Engineering Change Notification

Topic: Display modules with FT8xx chip

ACTUAL AUDIO FILTER CIRCUIT

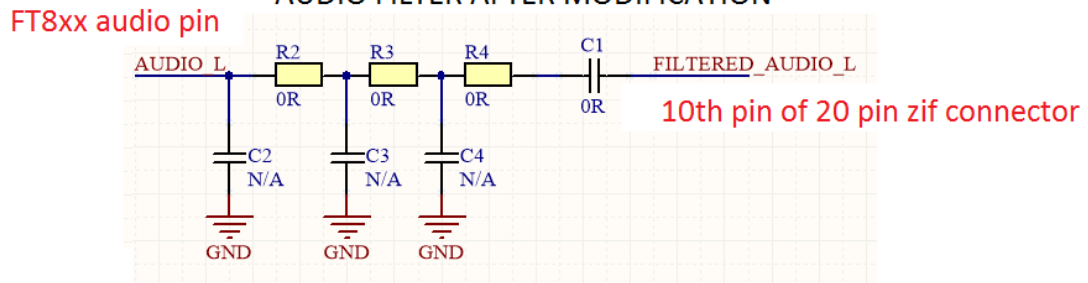
We have performed several tests of the audio channel and in certain customer applications the post-filtered audio signal has a very low SNR. As a result of this investigation we now recommend that the audio signal is processed on the customer's PCB.

The audio filter circuitry will now be short circuited from the FT8xx allowing customers to carry out this filtering on their own PCB

The change will be applied to displays manufactured from the 1st of June 2016.

On request, we will continue to supply the existing panels to support customers using the current filtered signal from the display."
